ADDENDUM ONE

Roofing and Related Work at Kettler Hall Roof Replacement Phase 1 - 2026:
Purdue University Fort Wayne
E Campus Drive
Fort Wayne, Indiana 46805

Commission No.: F26026
Addendum Date: July 7, 2026

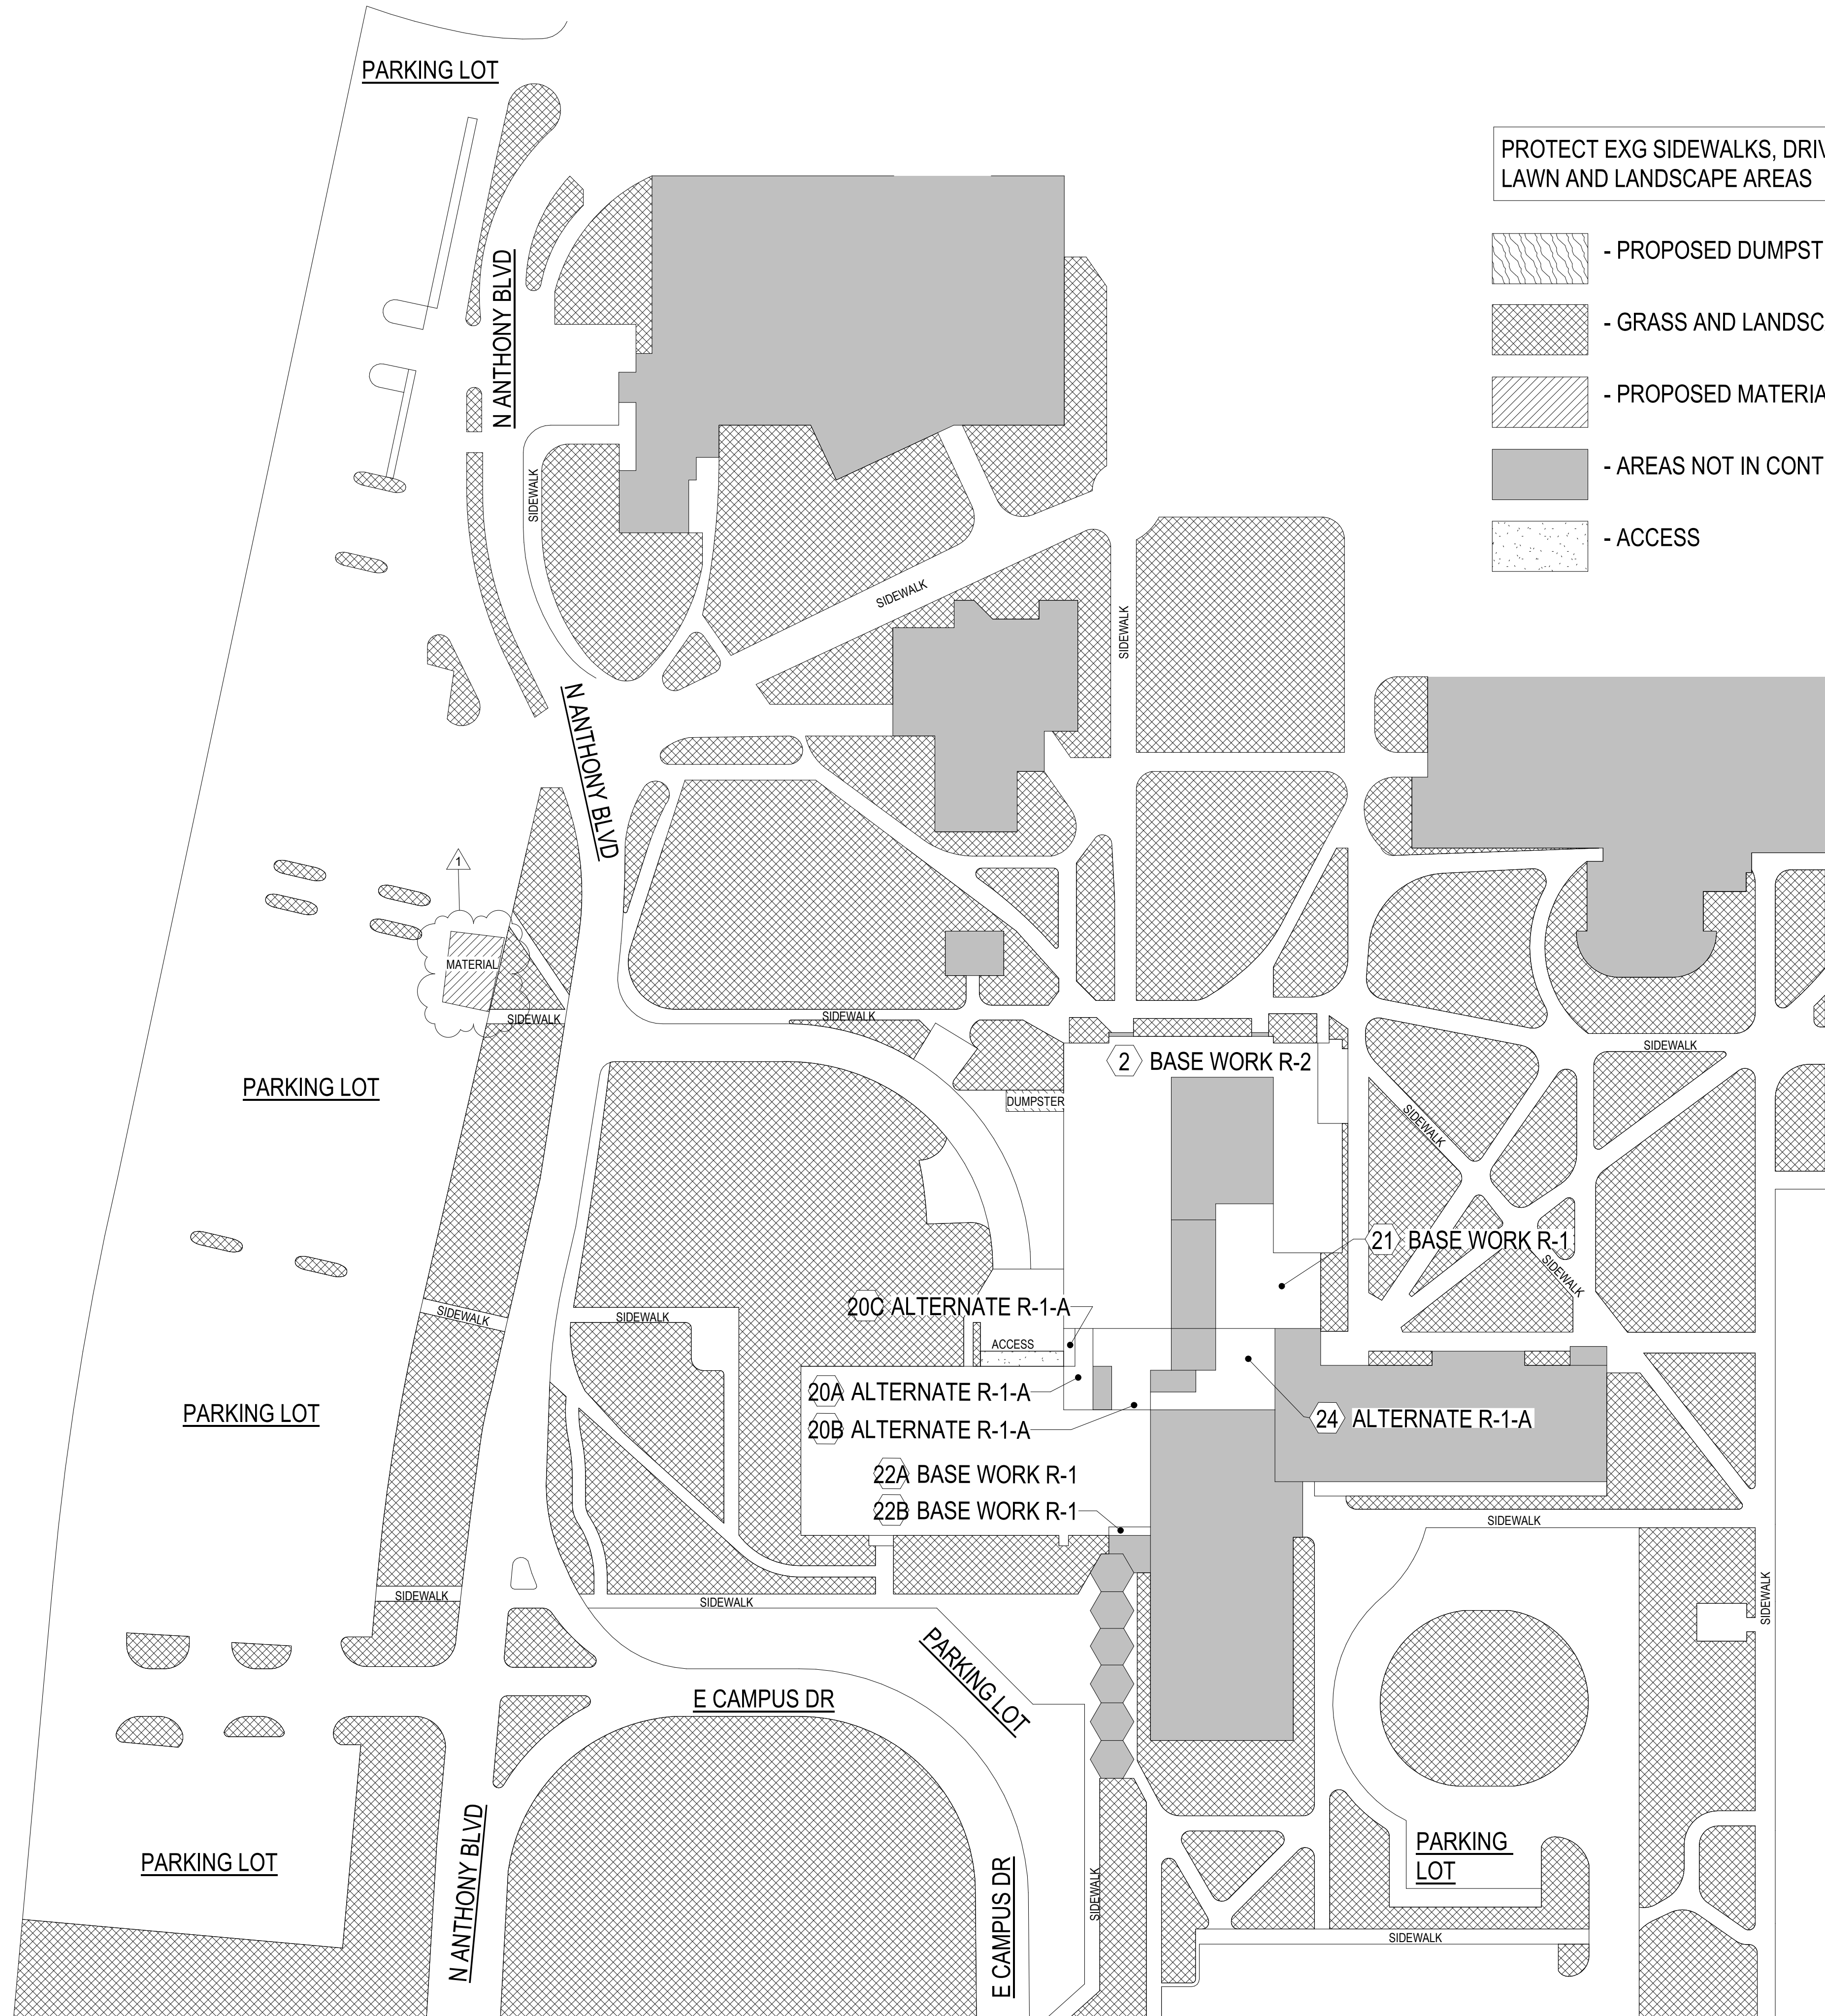
- (10) LOUVER VENTS WILL NEED TO BE REMOVED, SALVAGED AND REINSTALLED TO ACCOMMODATE INSTALLATION OF NEW THRU-WALL FLASHING SYSTEM.
- USG COMPANY; SECUROCK HAS BEEN REMOVED FROM THE SPECIFICATION MANUAL
